651S-1
GENERAL PURPOSE HF RECEIVER

PUB NO.	NOTE	DATE	SUBJECT
IB 1-72 ✓		03/01/72	Subassembly Interchangeability
SB 1		10/01/72	Reduction of 450-kHz Leakage From Synthesizer Reference Board All
SB 2		06/06/73	Reduction of Noise Level
SB 3		07/15/73	Add Keep-Alive Frequency Memory Function
SB 4		07/15/73	Extend Comma and Decimal Lamp Life in Frequency Display
SB A ✓		11/01/73	Change DCFE Filter Switching Diode
SB 5	1	12/15/74	Minimize TCU Circuit Card Response to Data Link Noise and Failure
SB 6	2	03/01/75	Reduce Intermodulation Level
SB 7		02/07/75	Reduce Internal Spurious Signals
SB 8		12/27/74	Allow Remote Control Operation With RS-232C Serial Control Interface Card A9
SB 9 ✓		02/15/75	Increase Life of Display Tubes
SB 10 ✓	2	12/31/75 Revised 08/02/76, 04/01/77	Replacing Display Tubes With LED Plug-in Assemblies
SB 11		Not issued	
SB B ✓		11/15/74	KAV
SB C ✓		01/15/78	Supply KAV Power to DCFE
SB 12 ✓		05/01/78 Revised 07/01/78	Replacing Nonprocurable Integrated Circuits

SERVICE BULLETIN A

SUBJECT: Change DCFE Filter Switching Diode

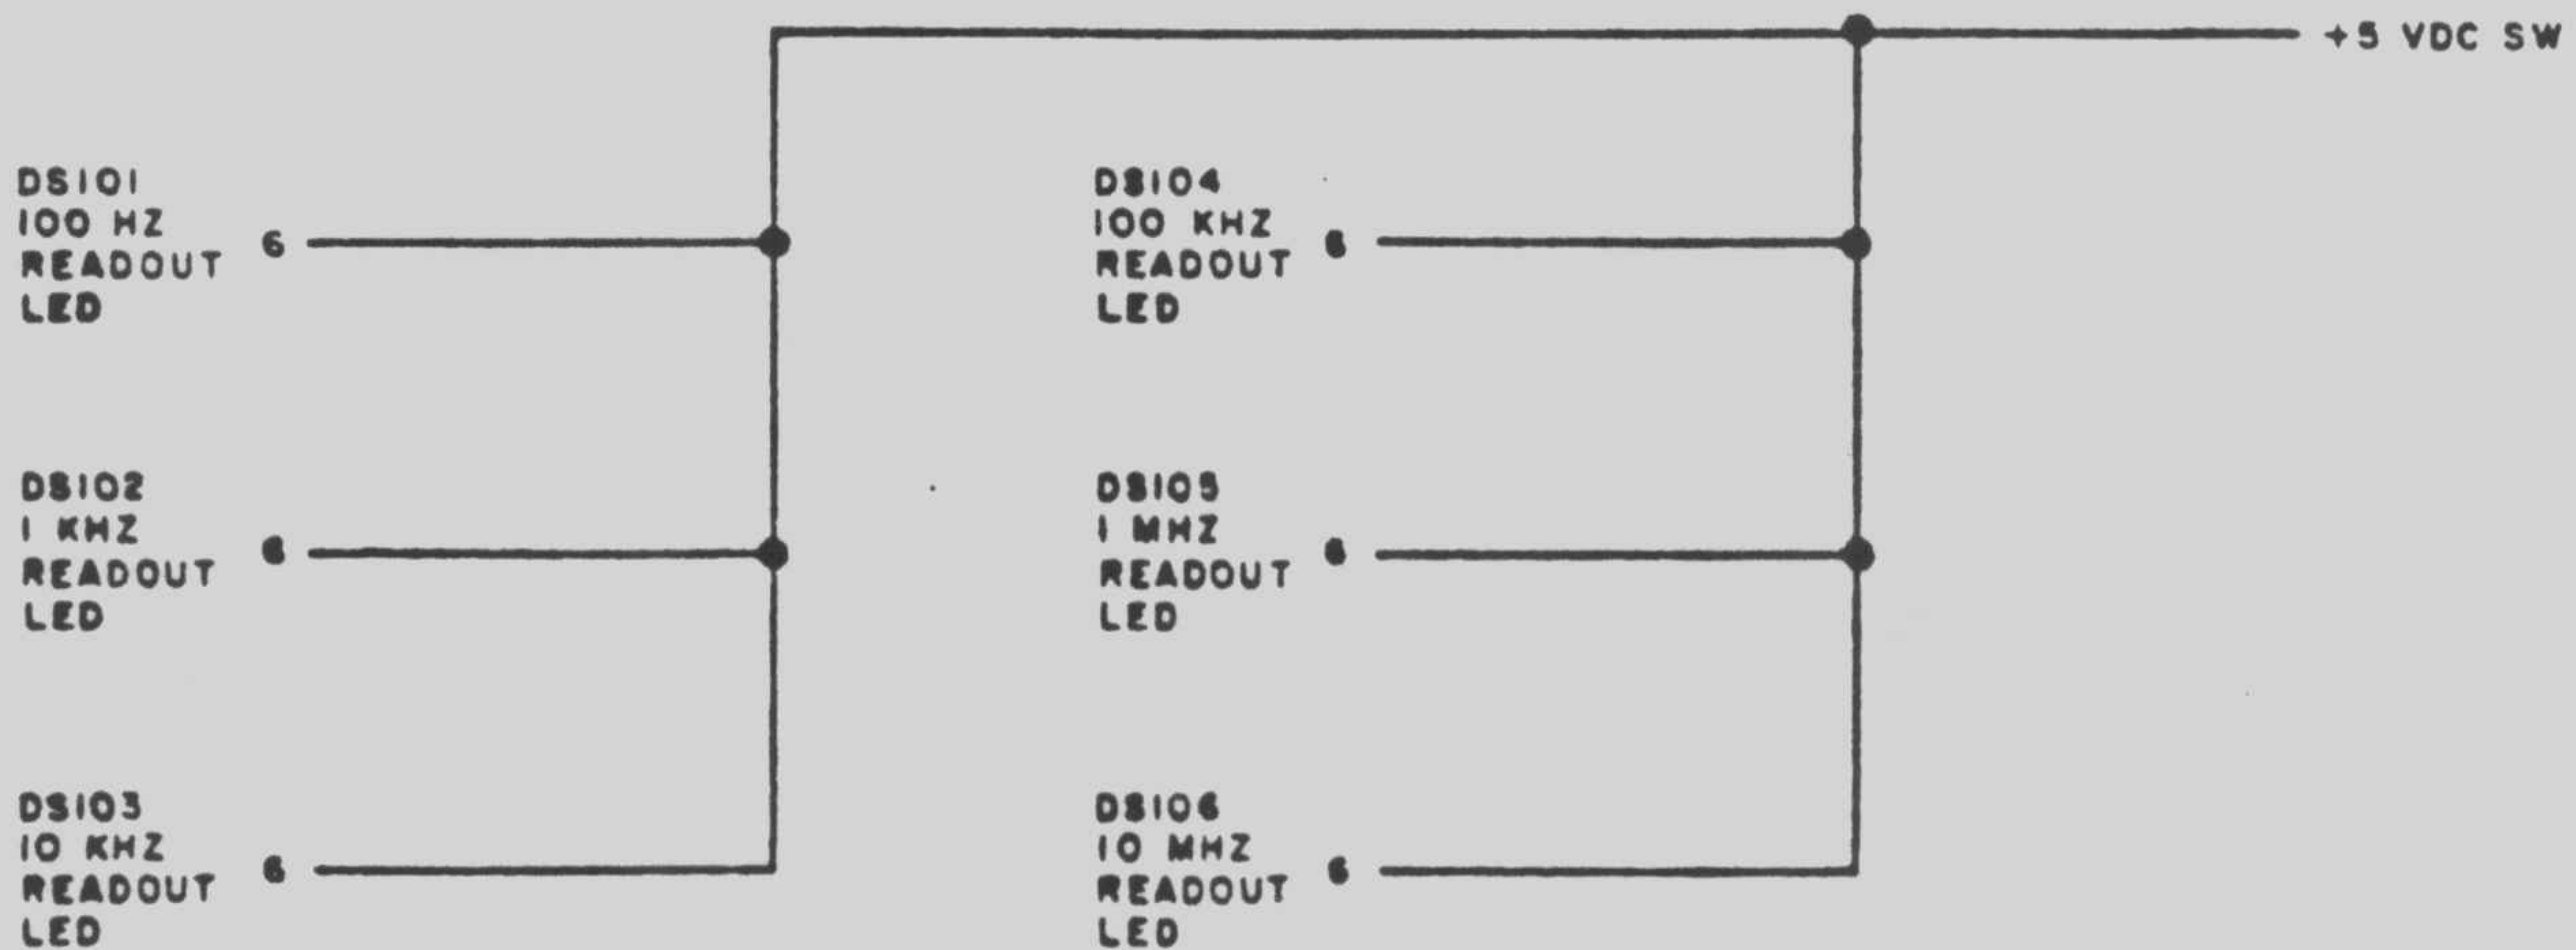
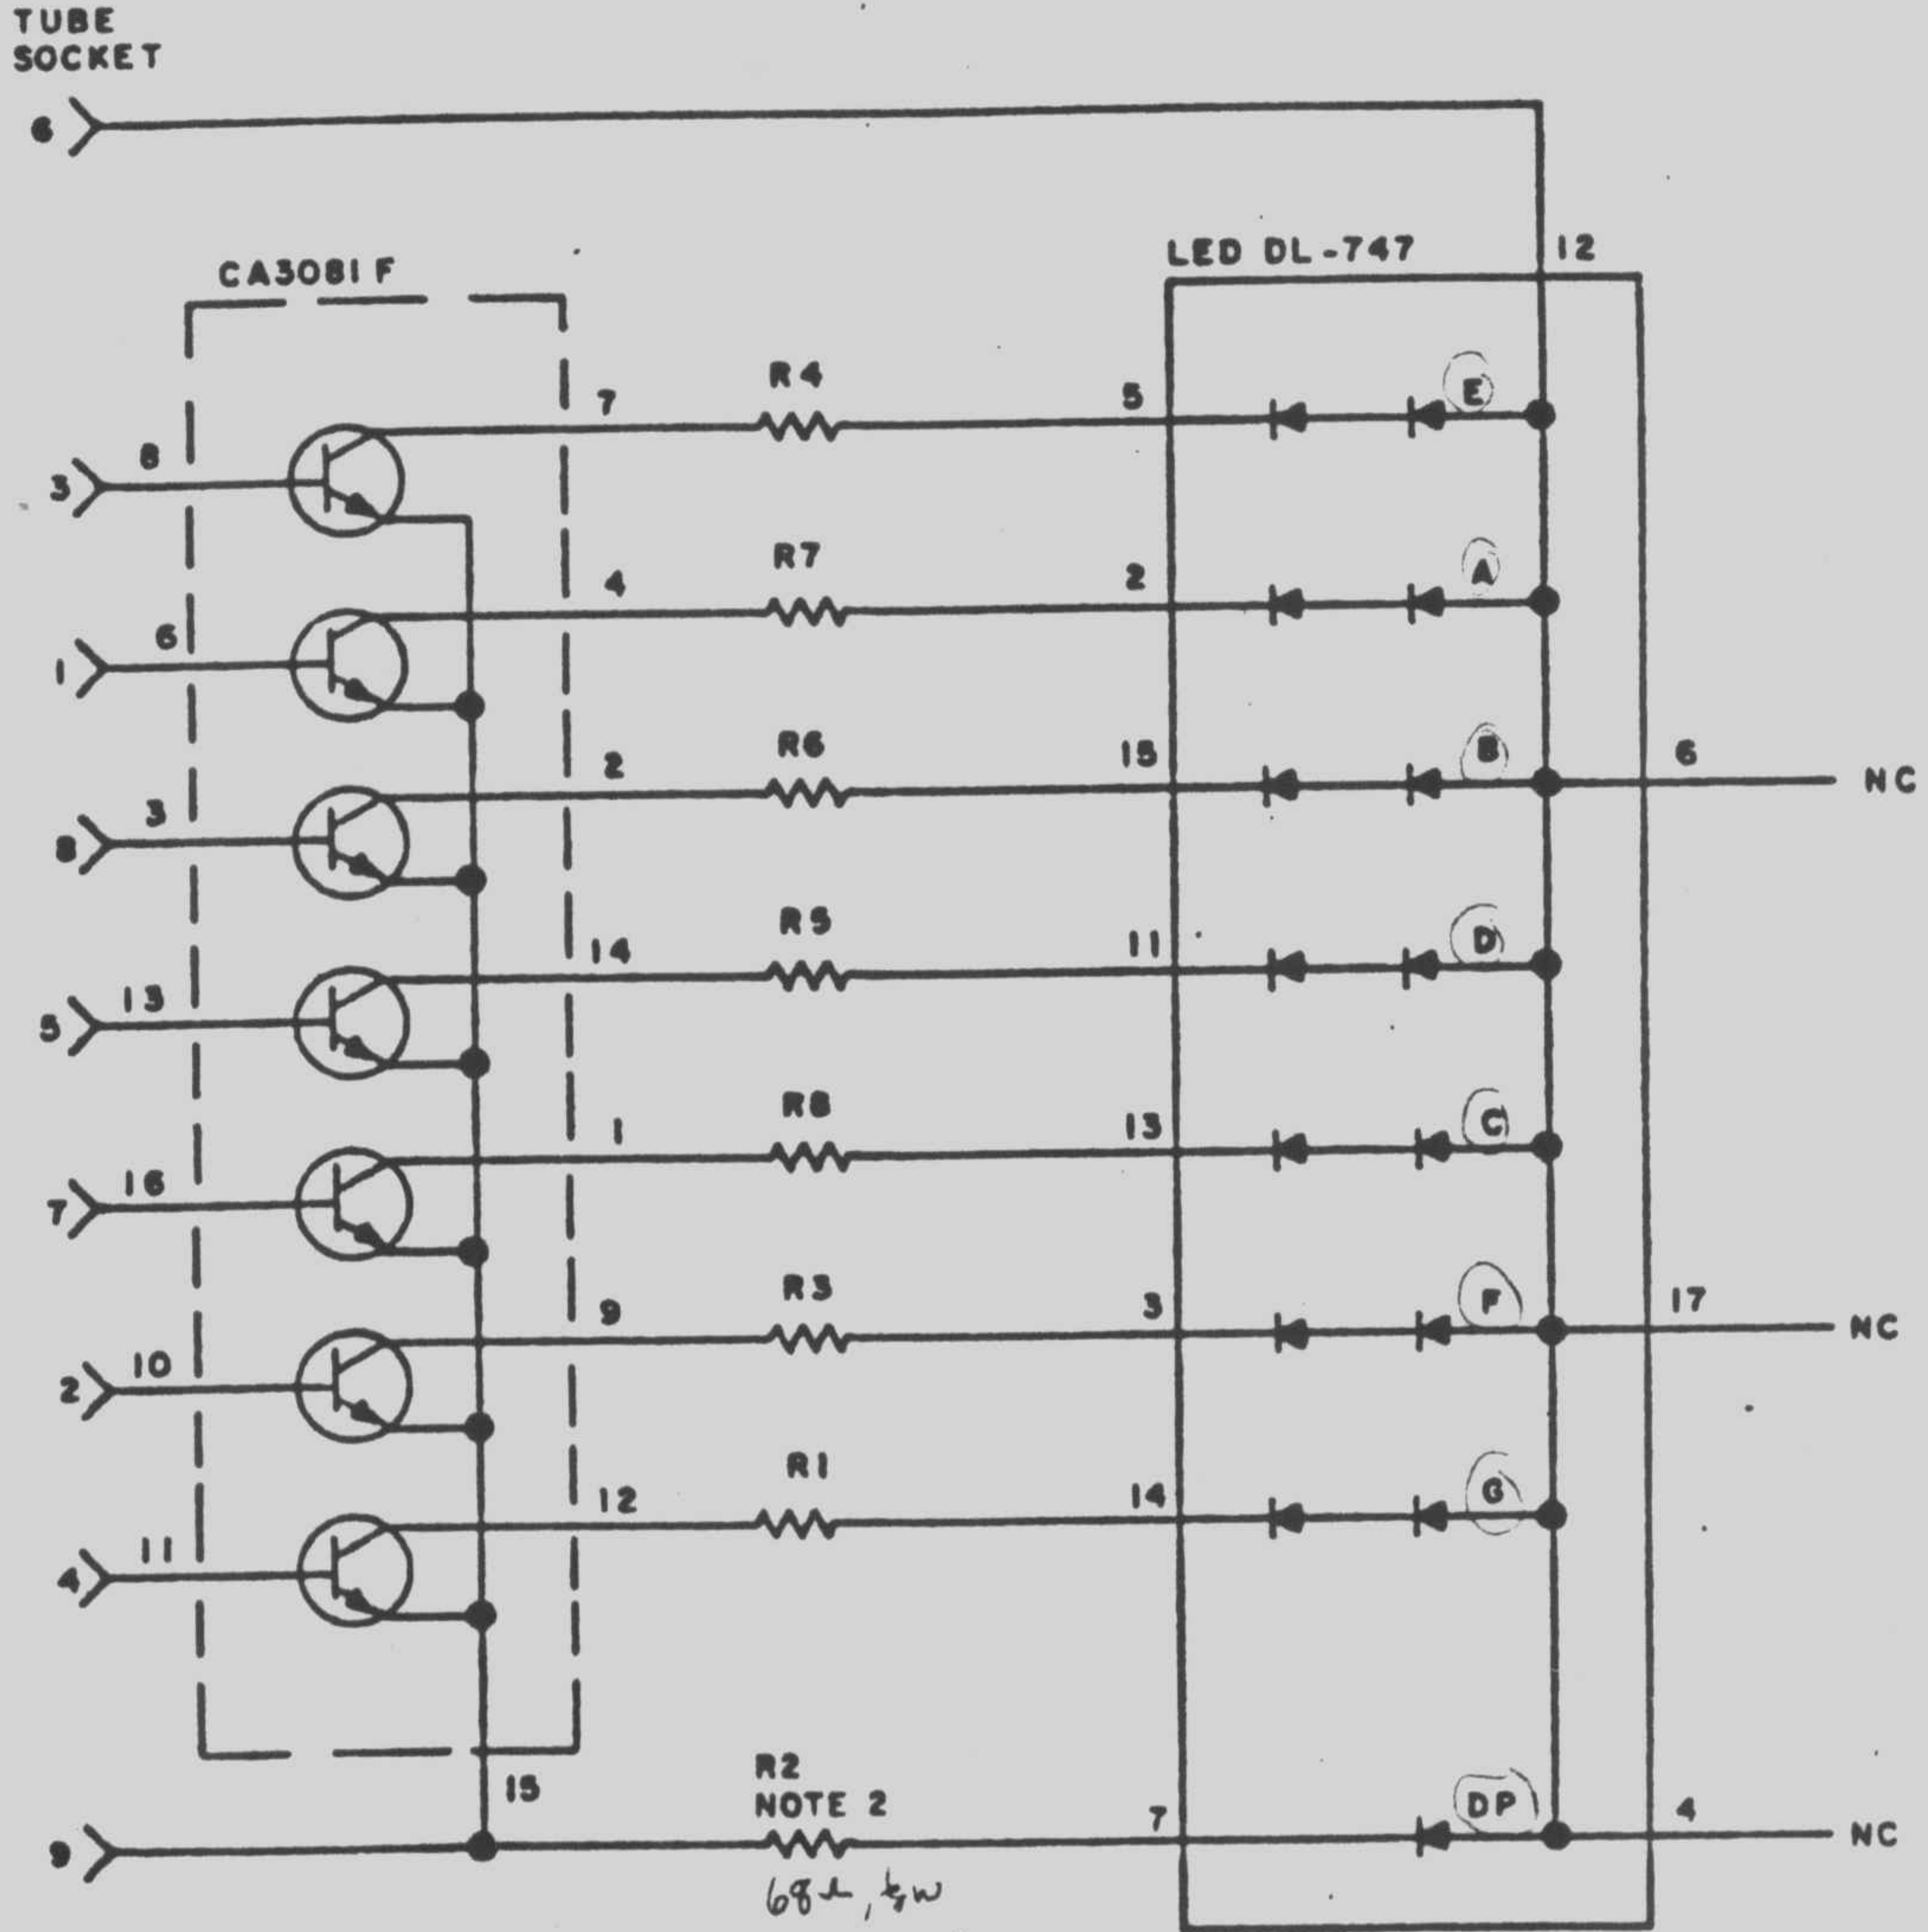
NOTE: Schematic modifications are shown in figure 2. Figure 3 is the schematic for the LED plug-in assembly.

P/O RF Mixer (606-9877-002)
Figure 1

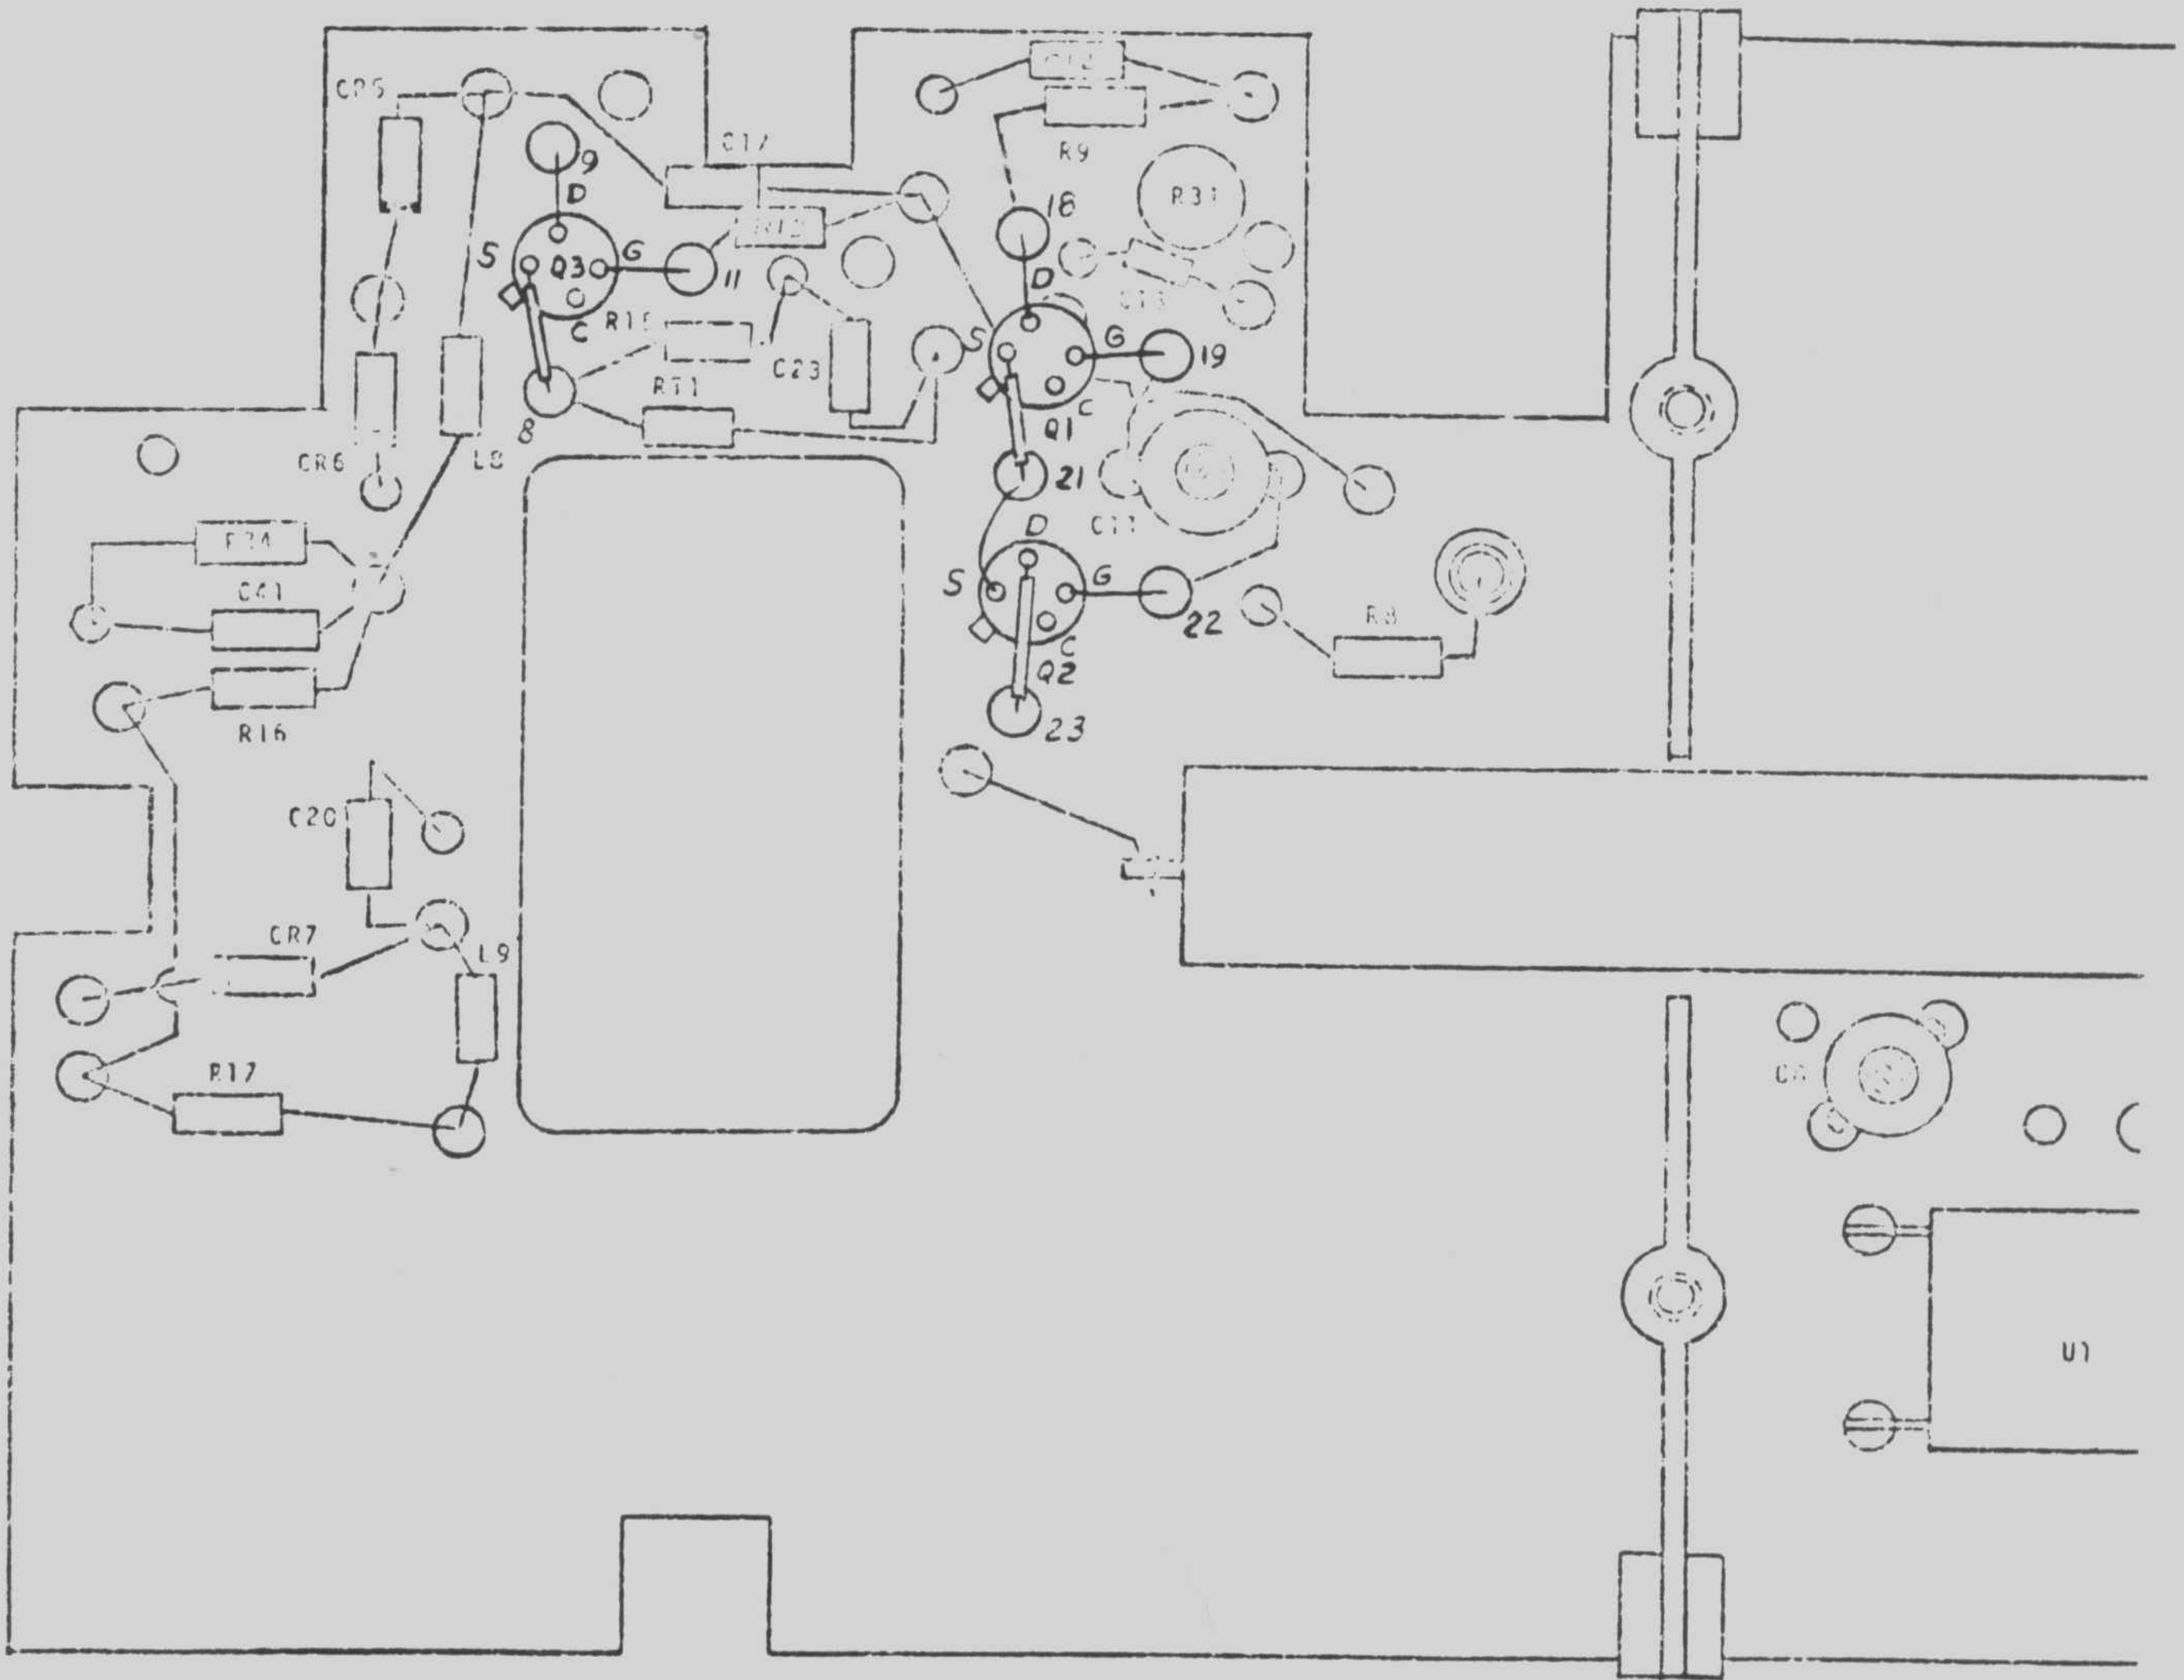
NOTE: Refer to figure 1 of this bulletin while performing steps F.(1) through (5).

- (1) Clip the case leads of the new transistors to a maximum length of 1.58 mm (1/16 in).
- (2) Install the transistors upside down on the chassis using adhesive (005-1688-001). Q1 and Q2 must have the same vendor symbol for testing qualifications. Use insulation sleeving (152-2473-000) on all leads that cross over the transistor body.
- (3) Connect Q1 source to terminal 21, drain to terminal 18, and gate to terminal 19.
- (4) Connect Q2 source to terminal 21, drain to terminal 23, and gate to terminal 22.
- (5) Connect Q3 source to terminal 8, drain to terminal 9, and gate to terminal 11.
